STRUCTURE BULLETIN

Current Issues: Bridge Approach Fills

DATE: February 25, 2021
TO: Division Engineers
FROM: E. B. Tharrington, PE
State Construction Engineer
SUBJECT: Revisions to Bridge Approach Fill Details

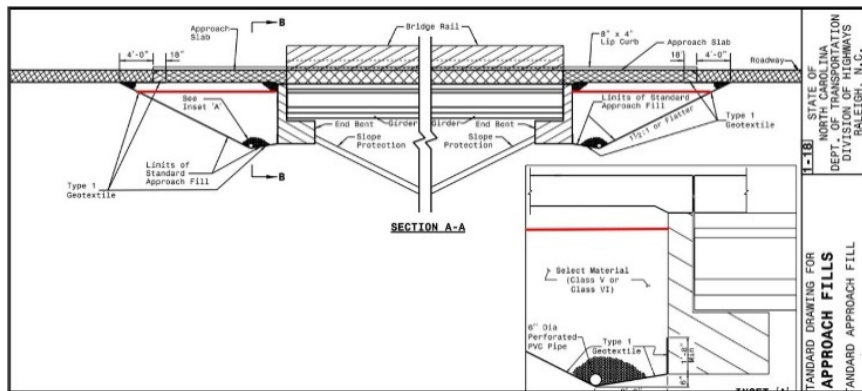
Voids & Settlement Repair Options: Other than a complete removal and replacement (which is not always practical, especially when open to traffic), there are only a few options to consider. Latex Modified Concrete Overlays can fix the ride but will not fill voids. Two options, grout and high-density polyurethane foam, have been used to fill voids and/or jack approach slabs that have settled. Each require specialized equipment and expertise and it is recommended that the Geotechnical Unit be contacted to discuss which option may be the most suited.

In 2018, the Roadway Standard Drawings were modified to only use coarse aggregate backfill (Type V or VI). Additionally, the reinforced approach fill was modified and eliminated the multiple layers of geotextile that were previously required. Although there were good reasons for the changes, it has become apparent that

these two changes have impacted the Department's ability to jack approach slabs that have settled. The grout and/or foam fills the void structure in the coarse aggregate and does not give a sufficient support system to jack and raise the approach slab. Therefore, an immediate modification is being made to all current contracts as

outlined in the attached memo from the State Construction Engineer. Essentially, a single layer of Type 4 or 5 geotextile should be added one foot below the approach slab. This will keep the grout or foam from continuing to permeate the stone below. It is important that proper placement and overlap is done, and that it is documented on the as-builts so that Geotech or Maintenance know that it is there. Further modifications to the standard drawings are being investigated. Payment can be made under existing line items for Geotextile, or in accordance with Article 104-7.
